Nant Mithil Energy Park, Powys.
PEDW DNS Application Ref: DNS CAS-01907-D7Q6Z1.

CPRW-RE-think Chapter 13 on

Public Rights of Way & Leisure Trails

Evidence by CPRW-RE-think on:

Figure 2: Turbine Cluster taken from Volume 2, figure 4.13

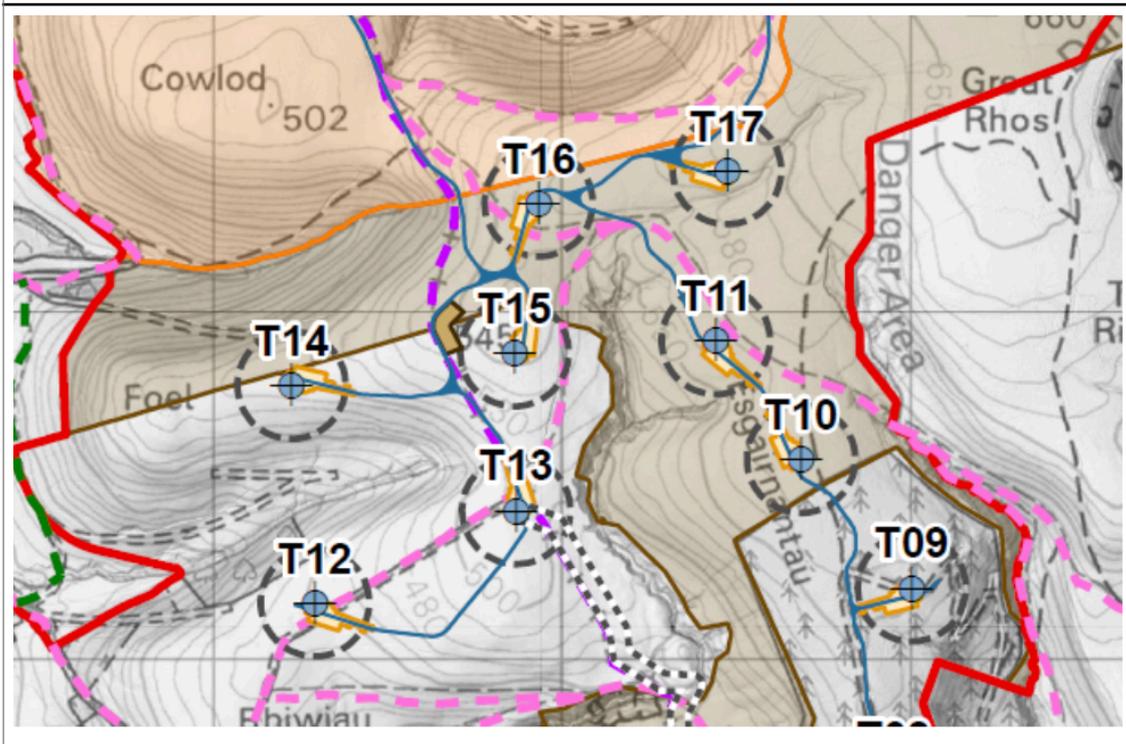
3.7. The cluster of turbines T11, T15, T16, T17 (see fig 2) surround 2 bridleways making them unsafe. T13 will also directly affect the BOAT and one of the bridleways. T13, T15 and T16 are close to the BOAT at points that could be perilous for equestrians because of the adjacent steep gradients. No rider would wish to divert between this cluster. Any route westwards is not an option because of the terrain. Any diversion to the East is away from the natural direction of travel and still requires passing within topple distance. As T13 would over-sail the BOAT there is also vehicular traffic to consider. Equestrians, cyclists or vehicles have no access rights over the Open Country or Common Land beyond the line of the PRow. We wonder if the applicant has had a conversation with both PCC and the landowners. Maybe landowners will not want a diversion, (temporary or permanent), on their land for any of many reasons. Neither is the need for gates onto the common considered. We need to know this information before determination of the application.
